R66 SERVICE BULLETIN SB-40

DATE: 6 January 2022

SUBJECT: F029-1 Tail Rotor Blade Cracks

EFFECTIVITY: P/N F029-1 tail rotor blade S/Ns 2410 thru 2589.

SPECIAL TAIL ROTOR PREFLIGHT INSPECTION

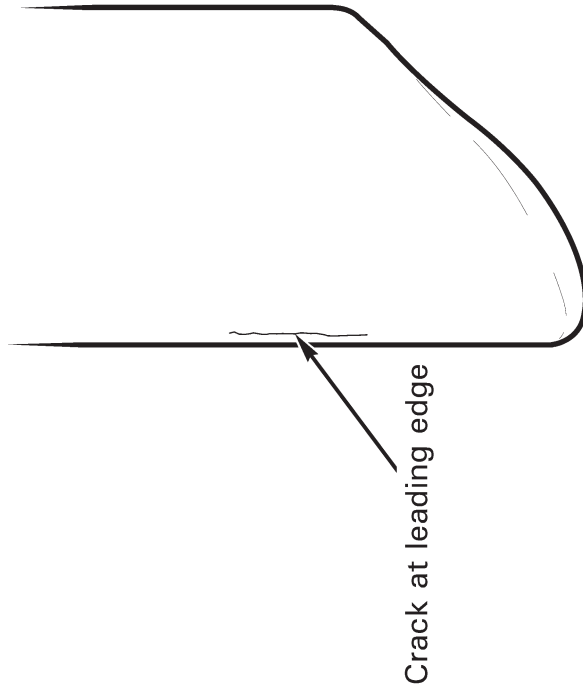
Refer to Figure below.

As part of each preflight inspection, perform detailed visual inspection of outboard 12 inches (30 cm) of blade leading edge. If any hairline crack similar to one shown in figure is found, aircraft is unairworthy. Replace blade prior to further flight.

Crack at leading edge
